CITY OF LA VISTA
MAYOR AND CITY COUNCIL REPORT
OCTOBER 15, 2013 AGENDA

Subject:	Type:	Submitted By:
LAKEVIEW SOUTH II, REPLAT 5	◆RESOLUTION ORDINANCE RECEIVE/FILE	ANN BIRCH COMMUNITY DEVELOPMENT DIRECTOR

RECOMMENDATION REPORT

RE: Application for Replat-Initial-Review
Lakeview South II Replat Five

PREFIMINARY PLAT

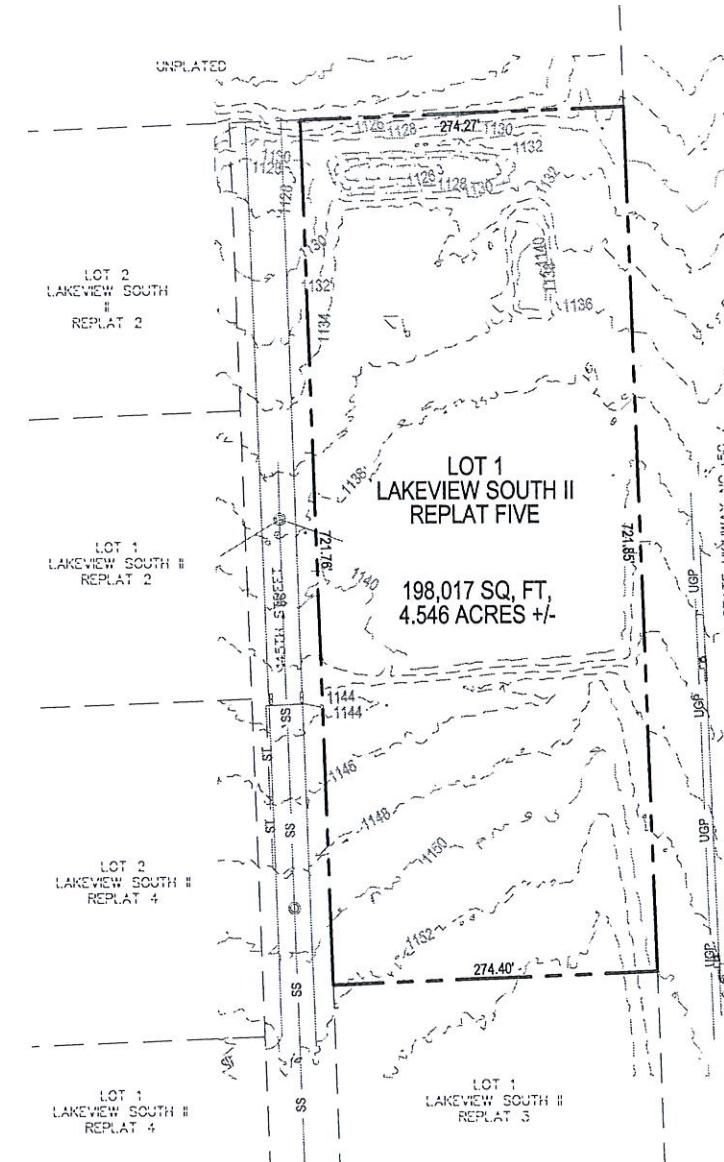
6. The preliminary plat was reviewed for compliance with Section 3.03 of the Subdivision Regulations. Items requiring further information are listed in the foregoing comments. Certain items are not applicable due to the nature of the proposed replat.

FINAL PLANS

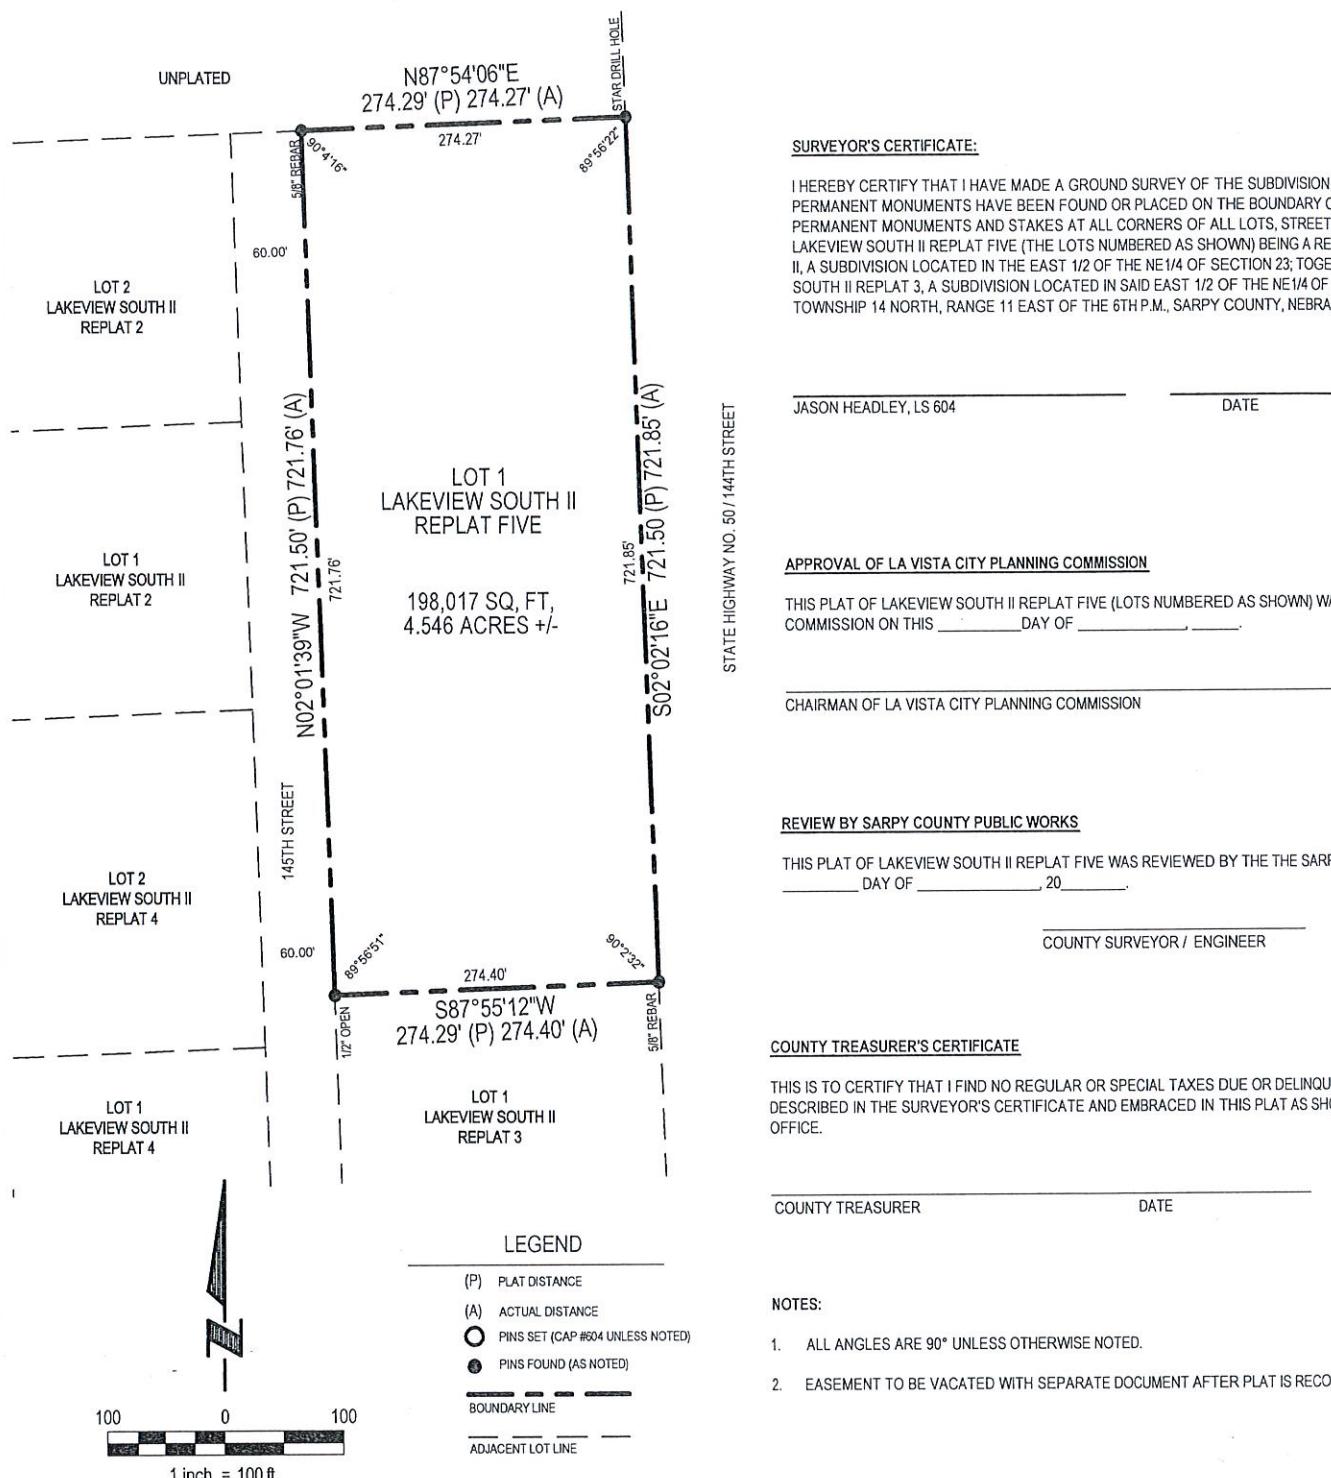
7. The final plat was reviewed for compliance with Section 3.03 of the Subdivision Regulations. Various items are not applicable due to the nature of the replatting, however, the applicant will need to request release of the side lot line easements along the common line between Lot 4, Lakeview South II and Lot 2, Lakeview South II Replat 3 that is being dissolved by this replatting. Releases from the affected utility companies need to be provided prior to the final plat mylars being signed by the City and released for recording.
